| Project        | <b>IEEE 802.16 Broadband Wireless Access Working Group</b> < <a href="http://ieee802.org/16">http://ieee802.org/16</a> >   |                      |
| Title          | <b>Comments on SDD Unicast Pilot Pattern</b>   |                      |
| Re:            | Category: SDD comments / Area: Chapter 11 (PHY)<br><br>"Comments on SDD 11 PHY"  |                      |

Figure XX Pilot Pattern B for 8 stream pilots, P<sub>k</sub> denotes pilot for stream k

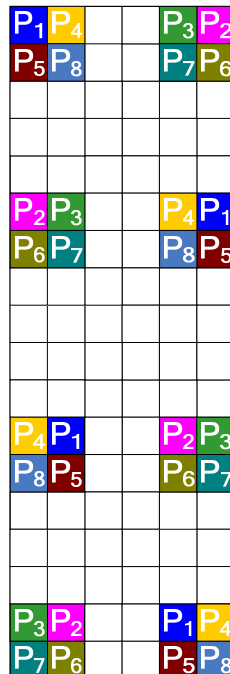
This contribution provides the new unicast pilot pattern for 8 streams as shown in Figure XX.

[In IEEE 80216m-08\_003r8, Section 11.5.3.1, Insert the following figure for 8 streams Unicast Pilot Pattern]
